**RE: Official Plan Amendment, Zoning By-law Amendment & Draft Plan of Subdivision
Resubmission #2– Response to Comments
400 Millennium Boulevard, Waterloo
OUR FILE 8784CX**

On behalf of our client, Activa Holdings Inc., and in conjunction with Stantec and Paradigm Transportation Solutions, we have reviewed the consolidated comments provided on March 3, 2025. The following table includes the comments and a response.

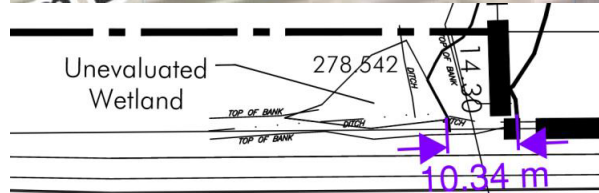
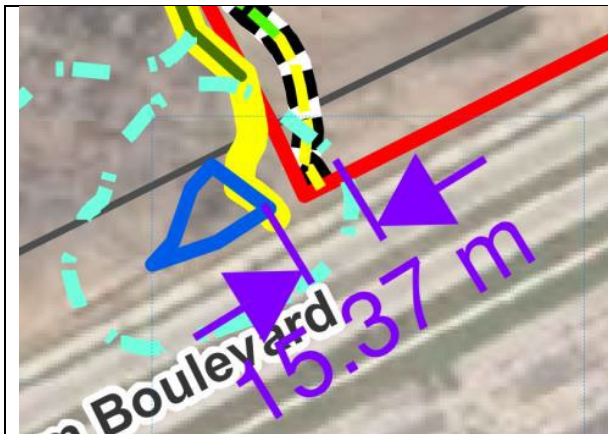
32. In your next resubmission, please fully address the following questions: a. How will the maintenance of the retaining wall occur overtime, given that there are potentially 15 different property owners?	Each homeowner will be responsible for maintaining their portion of the retaining wall. They will be advised through clauses in the subdivision agreement. The wording of the clauses can be determined after draft approval and would be subject to City review and approval.

b. How will future homeowners be informed about the retaining wall ownership and maintenance obligations?	Furthermore, maintenance responsibilities of the retaining wall will be registered on title for each lot.
Urban Design	Response
